Modification of Glendell Mine Operations Response to Submissions

Prepared by Umwelt (Australia) Pty Limited on behalf of Xstrata Mt Owen Pty Limited

Report No. 2461/R01/FINAL Date: October 2007

FIGURE 3.1

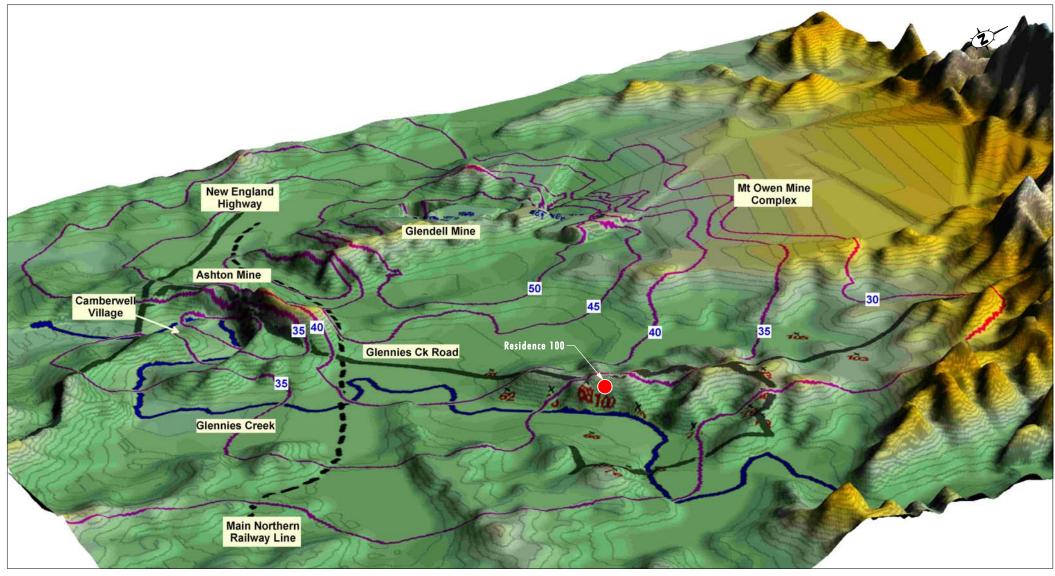
These issues were raised within a public submission in relation to Residence 100. As indicated on Figure 1.6 of the EA, Residence 100 is privately owned and is located approximately 2.5 km to the east of the Glendell Mine site. The location of this residence has been determined through review of aerial photography (current to December 2006) and confirmation by site observation.

The topographical data used in the ENM models, shown in **Figure 3.1**, indicates Property 100, located on the eastern side of Glennies Creek Road, is shielded from the modified Glendell operation by a natural landform immediately to the west of the property. The close proximity of a barrier like this can provide significant attenuation of noise. The results in the Noise Impact Assessment suggest the natural landform could provide attenuation in excess of 10 dB.

Figure 3.1 also shows how the propagation of noise in Year 1.5 under 3.0 m/s NW wind conditions is influenced by the changes in landform elevation. The Year 1.5 operations under 3.0m/s NW winds have been predicated as the worst case noise level from the modified Glendell operations within the Glennies Creek Road area. The influence of

Topographical Base for Environmental Noise Model landform elevation changes on noise levels, as shown in **Figure 3.1**, is consistent with the results predicted by ENM and replicated by industrial and infrastructure developers who use acoustic barriers to shield noise generating developments.
